FLAT ROOF PRODUCT LAYOUT GUIDELINES

SINGLE COLUMN ARRAYS, SUBARRAYS AND PROTRUSIONS

April 23, 2026

LIMITED CONFIGURATIONS

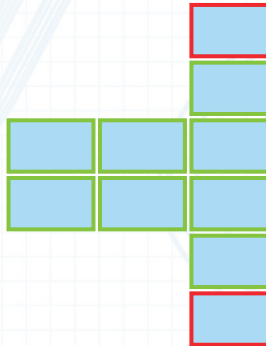
As such, we are now limiting the design of arrays for flat roof products with respect to single modules and single columns. New layouts designed by Unirac or submitted to Unirac through other means, such as Helioscope, will follow this new guideline. Existing projects in the field and projects designed prior to April 9, 2026, will not be impacted by this guideline.

Refer to the diagrams below which demonstrate these new design guidelines. Note that designing with panels in the 'Limited Configurations' outlined in the diagrams below require consultation with Unirac Commercial Services, and will likely result in additional ballast blocks and/or attachments.

SINGLE MODULES

SINGLE COLUMNS

CONNECTING BRIDGES WITH A LENGTH >2

SINGLE COLUMN ARRAY PROTRUSIONS
